Review of NEDE-33083P, Supplement 1, December 2004

**TRACG APPLICATION FOR ESBWR STABILITY
ANALYSIS**

Oak Ridge National Laboratory

Figure 1. ESBWR Hot Channel Void Fraction Profile Predictions.

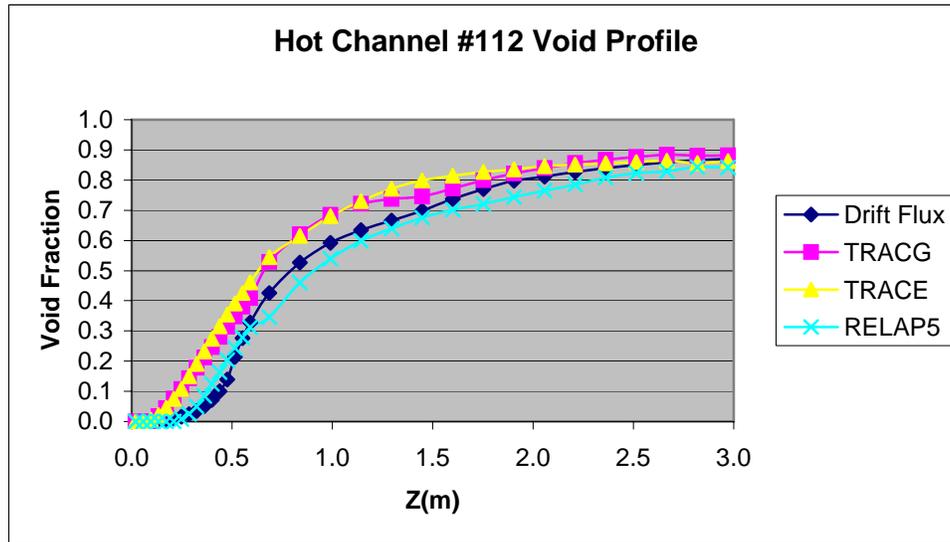
A standalone drift flux program for a single ESBWR channel was developed to estimate the steady-state void fraction and velocity profiles. The standalone drift flux program includes TRACG documented models (Reference 11) for the drift flux parameters and subcooled boiling. Based on this model the estimated density wave transport time for the ESBWR hot bundle is 0.1 seconds, which implies an instability frequency of

[] Hz. This is slightly below the lower range of expected frequencies for the ESBWR. One explanation for the difference in transport times is the difference in void fraction profiles between TRACG and the standalone drift flux program. Comparison of the void fraction profile predicted by the drift flux standalone program to TRACG, TRACE (Reference 12), and RELAP5 (Reference 13) for the ESBWR hot channel is given in Figure 1.

The TRACE models for subcooled boiling and bubbly flow and churn turbulent interfacial shear are similar to the TRACG models. Differences between the comparison of the drift flux model to TRACG and other codes are not significant given that the assessment of TRACG against bundle and large diameter void fraction data indicate that TRACG models are accurate.

Overall the comparison between TRACG, TRACE, and the standalone drift flux model supports the TRACG void fraction profiles. Differences between the drift flux model and TRACG can be attributed to the incompressible two-phase flow assumptions in the drift model and the lack of virtual mass terms in the drift flux model. RELAP5 is using a completely different interfacial shear package and is not expected to compare well with TRACE or TRACG.
